IREDELL COUNTY HEALTH DEPARTMENT

IMPROVEMENT PERMIT / AUTHORIZATION TO CONSTRUCT / OPERATION PERMIT / EXISTING SYSTEM INSPECTION

PERMIT# 144183 PIN# 4730130805 DATE 9/23/07

SUBDIVISION PARKSTONE BLOCK / SECTION ____ LOT 8 LOT AREA 1.044 SITE CLASS. PS DESIGN FLOW 480 L.T.A.R. .3

Plot Plan SURVEY OF

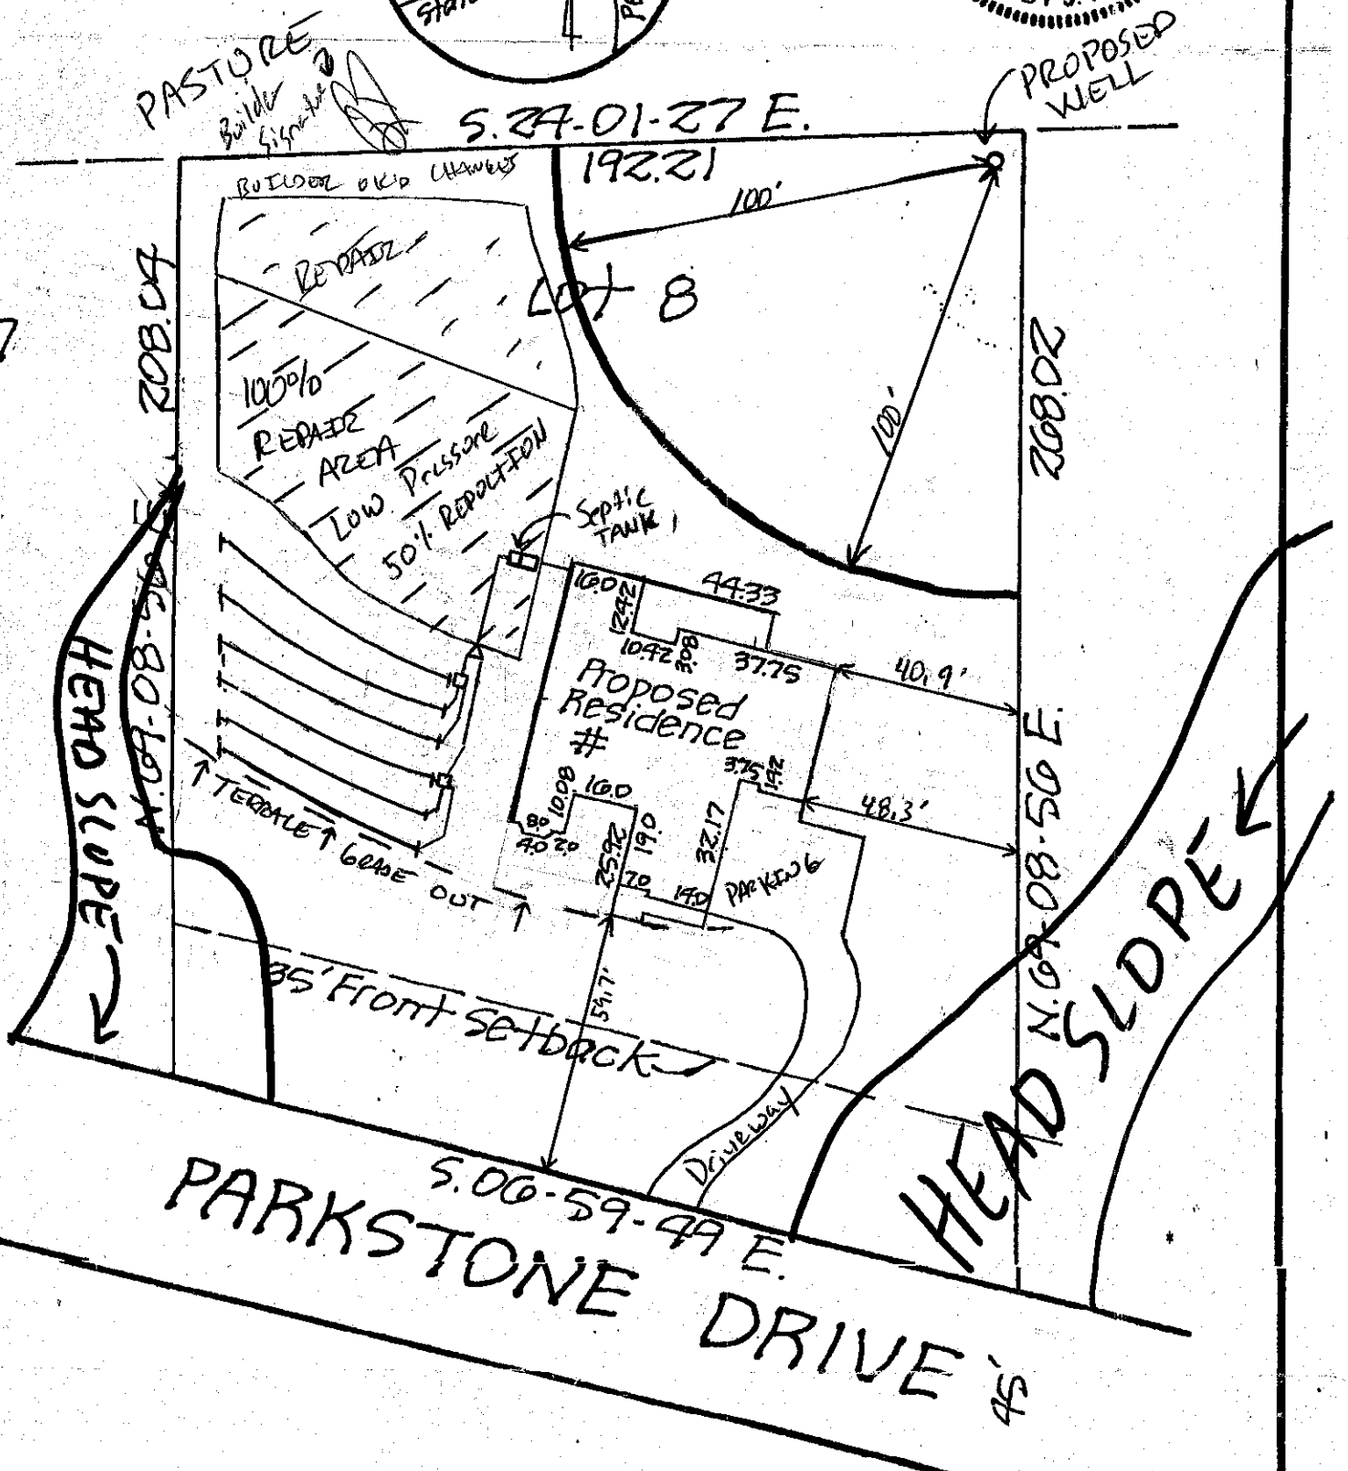
Comments/Conditions: (1) Discussed ALL SETBACKS WITH BUILDER (2) Install Lines on Contours & MAINTAIN SETBACKS (3) INSTALL 6 LINES 45' LONG, USING 1 FLOW DIVIDER TEE &

Comments/Conditions: 2 Distribution Boxes with speed levelers, (4) DUE TO SAPROLITE, 100' WELL SETBACK MUST BE MAINTAINED (5) SYSTEM SIZED FOR A 4 BEDROOM HOME, ONLY PLANNING A 3 BEDROOM HOME

10-8-07, MET BUILDER & MARK CLOSEST TO SEPTIC LINES will have (6) foundation drains, Lines, by measurements done on lot, will still be 15' from drain & sippys will be 10' from drain. If this cannot be maintained Pump System maybe required, Drain, per builder, will have to go through Right wing wall foundation

WELL IS 136' From TANK POLY LOK Filter & RISERS
